ASTA Low Energy Absorber Thermal Analysis

Version 4, Feb 07 2012

Beam Doc DB ID: Beams-doc-4063

Design review held on Jan 11 2012

Thermal Contact Sensitivity

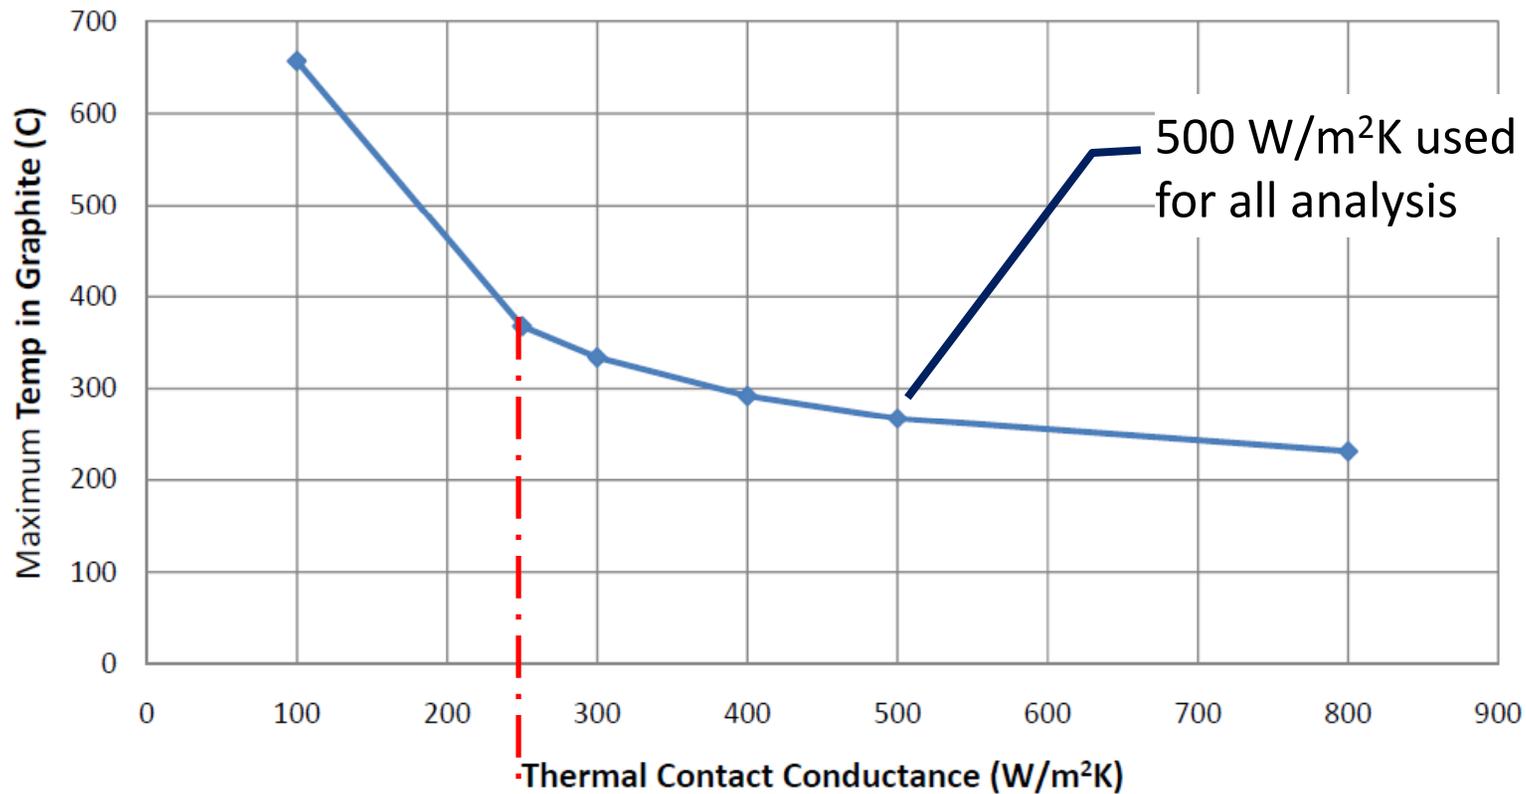
- Given the acknowledged sensitivity to C/Al thermal contact, the reviewers recommended calculating a worst-case thermal contact by looking at conduction across a small (unintentional) air gap.

- The contact thermal conductance for a 30um air gap is given as:

$$C = k_{\text{air}}/t_{\text{gap}} = (.0263 \text{ W/m K}) / (0.00003\text{m}) = 876 \text{ W/m}^2 \text{ K}$$

- So, the assumed contact thermal conductance of 500 W/m² K is quite conservative. We can expect to be on the “flat” part of the curve shown on the previous slide

Review Recommendations: MARS model for single-pulse effects

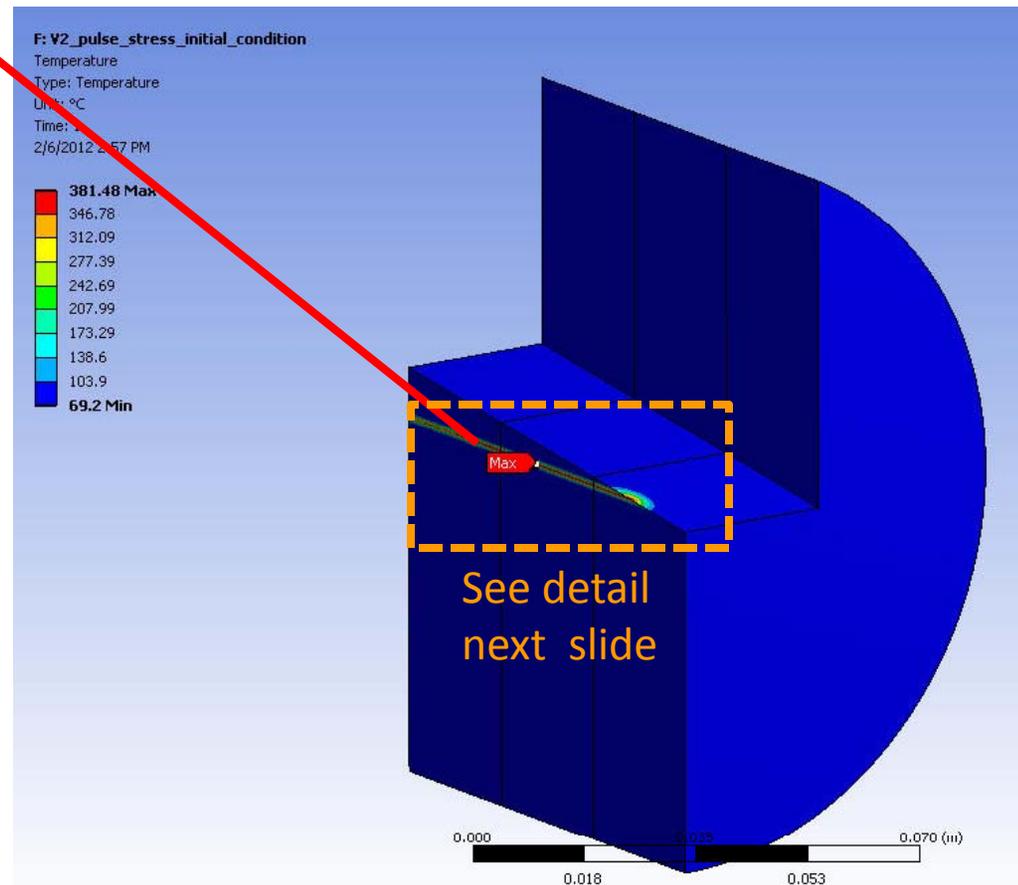
Review Recommendations: MARS model for single-pulse effects

- In the presented analysis, a scaling approach was used to calculate the Gaussian peak of the local, instantaneous energy deposition associated with single pulses. (See slides 50-61)
- The review panel recommended building an explicit, fine MARS model to better capture beam incidence effects and confirm the scaling approach
- Igor Rakhno built such a model
 - MARS element sizes are very fine as compared to beam size:
 $0.1\sigma_x \times 0.1\sigma_x \times 1\text{mm}$
 - Peak energy deposition compares well ($\sim 10\%$) with that obtained by scaling approach
 - This explicitly modeled value is considered to be more accurate, and is used for subsequent single-pulse calculations in this appendix.

- Localized High-resolution MARS model built for beam incidence area
- Maximum energy deposition (very near beam incidence) = .0802 GeV/(g*e-)
- This compares well with calculation done by large-cell scaling. This estimate is ~9% higher.
